**RE: Upper North Fork Feather River Hydroelectric Project, FERC Project No. 2105**

**PG&E COMMENTS TO SWRCB ON  
REVISED DRAFT EIR  
DATED JULY 7, 2020**

**PACIFIC GAS AND ELECTRIC COMPANY'S  
COMMENTS ON THE  
REVISED DRAFT ENVIRONMENTAL IMPACT REPORT  
FOR THE UPPER NORTH FORK FEATHER RIVER  
HYDROELECTRIC PROJECT LICENSE**

**Figure 10b Model Input Comparison of Spring Inflows, 2000 Calibration**

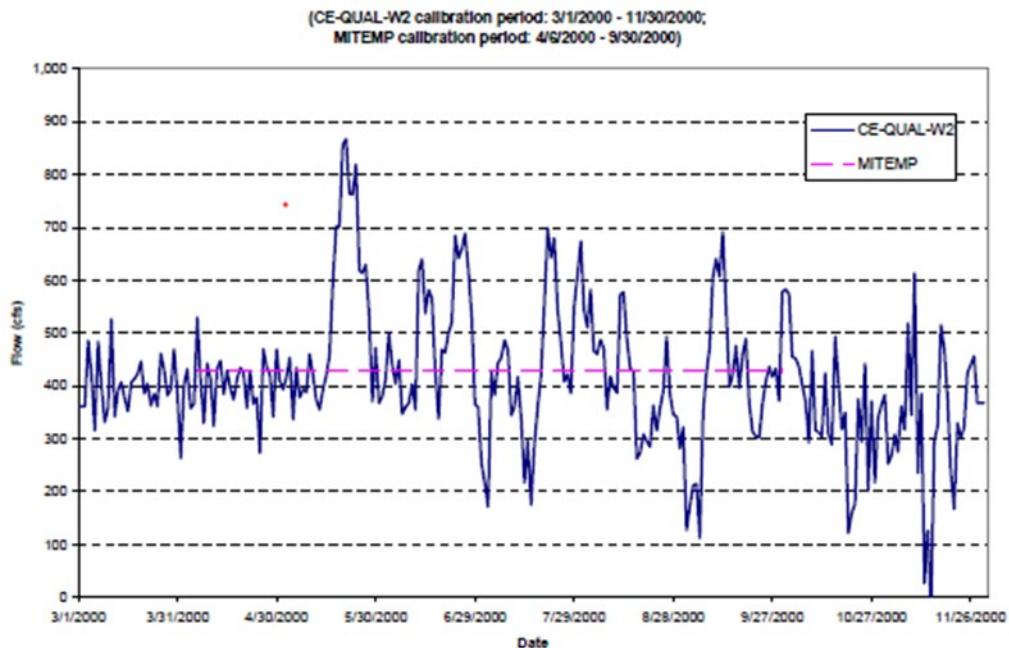
SWRCB aligned the two model inputs by using the same constant spring flows for the CE-QUAL-W2 model. This over-simplification forced by the need for consistency with the other oversimplified model (MITEMP) results in poor performance of the CE-QUAL-W2 model in terms of water balance (see figures below for simulated water surface elevation for Lake Almanor and Butt Valley Reservoir). The results are highly unreliable and do not provide credible support for the conclusions in the RDEIR.
